**TECHNICAL BULLETIN**  
**Bell Helicopter** **TEXTRON**

No. 212-04-199

**SUBJECT:** NEW CHIP DETECTOR INTERFACE PROBLEM  
WITH THE MASTER CAUTION PANEL

**HELICOPTERS AFFECTED:** Model 212 helicopters S/N 30501 through 31311,  
S/N 35001 through 35103.

Figure 1

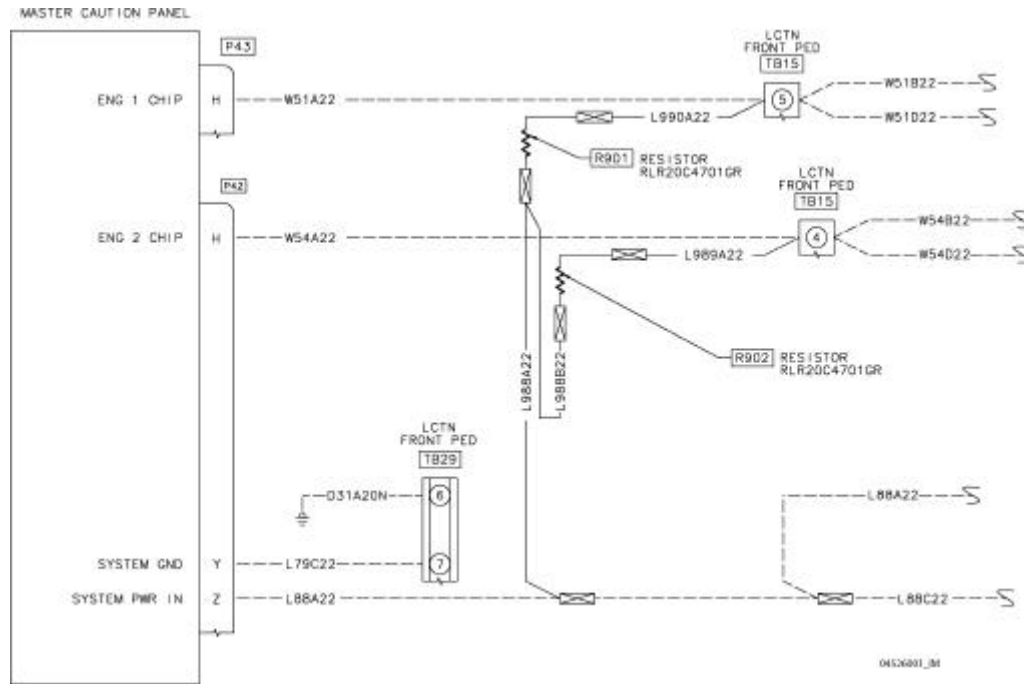
Operators have reported improper operation of the master caution panel after installing new engine chip detectors in accordance with Pratt & Whitney service bulletins 5411 and 5354. With the new chip detectors installed and the caution panel dimmed, the pilot and copilot Master Caution light may illuminate, although the ENG CHIP caution light does not illuminate.

This bulletin eliminates the problem by introducing 2 pull up resistors that ensure proper chip detector input to the Master Caution panel.

4. Gain access to terminal block, TB 15, located in front of the pedestal.
5. Crimp a terminal, P/N MS25036-102; to new wire L990A22 using crimping tool P/N M22520/5-01 and die assembly M22520/5-100. Connect the wire onto terminal 5 of terminal block TB 15.

6. Crimp a terminal, P/N MS25036-102; to new wire L989A22 using crimping tool P/N M22520/5-01 and die assembly M22520/5-100. Connect the wire onto terminal 4 of terminal block TB 15.

7. Using a heat gun, cover the leads of both resistors (R901 and R902) P/N RLR20C4701GR with black tubing P/N M23053/5-103-0, trim the shrink back off of the resistor leads in order to attach a splice.

8. Using a heat gun, cover the core of both resistors P/N RLR20C4701GR with clear tubing P/N M23053/8-005-C.
9. Using a solder splice, P/N M83519/1-2, connect wire L990A22 to resistor R901.

10. Using a solder splice, P/N M83519/1-2, connect wire L989A22 to resistor R902.
11. Using a solder splice, P/N M83519/1-2, connect new wire L988B22 to resistor R902.

12. Using a solder splice, P/N M83519/1-2, connect wire L988B22 to resistor R901 and to new wire L988A22.
13. Locate existing wire L88A22, cut wire L88A22 near connector (P42) of the master caution panel.

14. Using a splice, P/N M81824/1-2, connect wire L988A22 to both segments of wire L88A22.
15. Using a multimeter, perform the following continuity check.
